## **AIR ONE SUBDIVISION**

The preliminary plat illustrates the proposed 8-lot, 12.2± acre subdivision which is located on the South side of Airport Boulevard, 315'± East of Snow Road. The site is within the Planning Jurisdiction and the applicant states that the subdivision is served by city water and sewer systems. The purpose of this application is to create eight legal lots of record from one legal lot.

APPLICATION NUMBER 12 DATE October 20, 2016

# DETAIL SITE PLAN

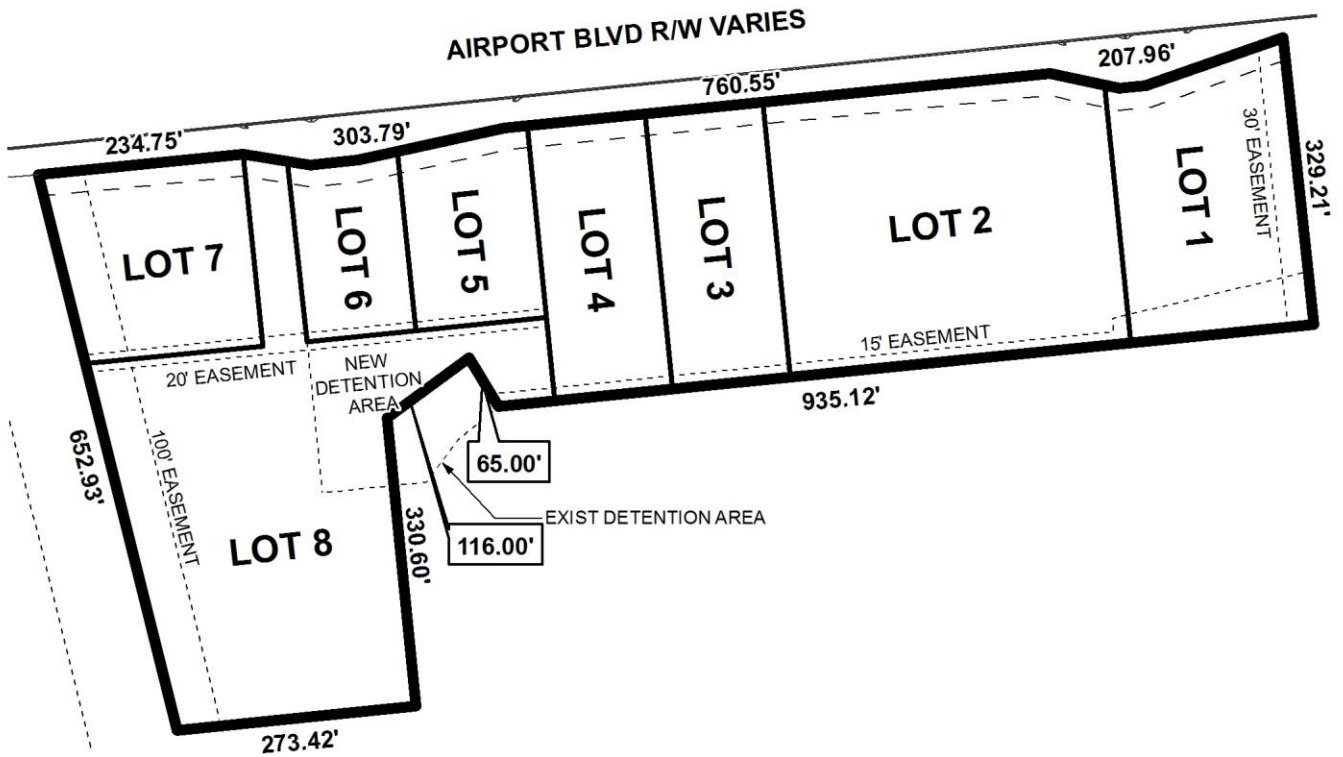
As previously stated, the proposed lots front Airport Boulevard. Airport Boulevard is a major street as illustrated on the Major Street Component of the Comprehensive Plan. As a major street, this street requires a 100' right-of-way width. The right-of-way width is depicted as "varies" on the preliminary plat; however, it should be revised to reflect the minimum existing right-of-way width or distance to centerline. Dedication requirements were addressed as part of the 2008 approval.

The irregular shape of the proposed Lot 8 creates a *flag lot* configuration, and as such, will require a waiver of Section V.D.1 of the Subdivision Regulations. Per the applicant, the justification for the flag lot is needed in order to allow access to the proposed Lot 8 from Airport Boulevard. Currently, there are no flag lots located within the immediate vicinity of the subject site; however, a waiver of Section V.D.1 of the Subdivision Regulations is necessary in order to gain access to the interior lot.

Due to the irregular shape of Lot 8, a note should be placed on the Final Plat stating that there shall be no additional subdivision until additional frontage on a paved public or private street is provided.

In accordance with Section V.D.2. of the Subdivision Regulations, the proposed lots exceed the 7,200 square foot minimum lot size requirements for lots served by city water and sewer systems. The lot size information is depicted in both square feet and in acres on the preliminary plat in the *Site Data* section of the plat; however, the acreage should be indicated for each lot as well. If approved, the Final Plat should be revised to indicate the lot size information in both square feet and in acres for each proposed lot.

The 25-foot minimum building setback line is depicted on the preliminary plat for proposed Lots 1 through 7; however, the proposed Lot 8 does not depict the 25-foot minimum building setback line. The 25-foot minimum building setback line should be retained for Lots 1 through 7, and the proposed Lot 8 should be revised to illustrate the minimum building setback line for Lot 8, where it is at least 60-feet in width on the Final Plat, if approved.

There is a 30' Drainage and Utility easement depicted along the eastern perimeter of the proposed Lot 1 on the preliminary plat, as well as a 15' Drainage and Utility easement with varying widths of 60'± to 32'± depicted along the southern portion of this lot. Also, there is a 15' Drainage and Utility easement depicted along the southern portion of the proposed Lots 2, 3, 4, in addition to the northeastern portion of Lot 8 on the preliminary plat. Furthermore, there is a 20' Drainage and Utility easement depicted on the preliminary plat between the southern perimeter of the proposed Lots 5, 6, 7 and the northern perimeter of the proposed Lot 8. These easements should be retained on the Final Plat, if approved, as well as a note stating that no structures are allowed in any easement.

A portion of a 100' wide Alabama Power Company right-of-way is depicted along the western edge of proposed Lots 7 and 8. The 100' right-of-way should be retained on the Final Plat, if approved, and a note should be added stating that no structures are allowed in the right-of-way without the approval of Alabama Power Company.

Due to the range of frontage widths for each lot along Airport Boulevard, and as a means of access management, a note should be placed on the Final Plat, if approved, stating that Lots 1, 3, 4, 5, 6, 7, and 8 are limited to one curb-cut each to Airport Boulevard and that Lot 2 is limited to two curb-cuts, with the size, design and location of each curb-cut to be approved by Mobile County Engineering and conform to AASHTO standards.

- 1) Labelling of minimum right-of-way width or distance to centerline;
- 2) Placement of a note stating that there shall be no additional subdivision until additional frontage on a paved public or private street is provided;

- 3) Revision of the Final Plat to indicate the lot size information in both square feet and in acres for each proposed lot;
- 4) Retention of the 25' minimum building setback line along Airport Boulevard for Lots 1 through 7;

- 5) Revision of the Final Plat to depict the minimum building setback line for Lot 8, where it is at least 60' in width;
- 6) Retention of all drainage and utility easements and Alabama Power Company right-of-way on the Final Plat, as depicted on the preliminary plat

- 7) Placement of a note on the Final Plat stating that no structures are allowed in the easements, and no structures are allowed in Alabama Power Company right-of-way without Alabama Power Company approval;

- 8) Placement of a note on the Final Plat stating that Lots 1, 3, 4, 5, 6, 7, and 8 are limited to one curb-cut each to Airport Boulevard and that Lot 2 is limited to two curb-cuts, with the size, design and location of each curb-cut to be approved by Mobile County Engineering and conform to AASHTO standards.;
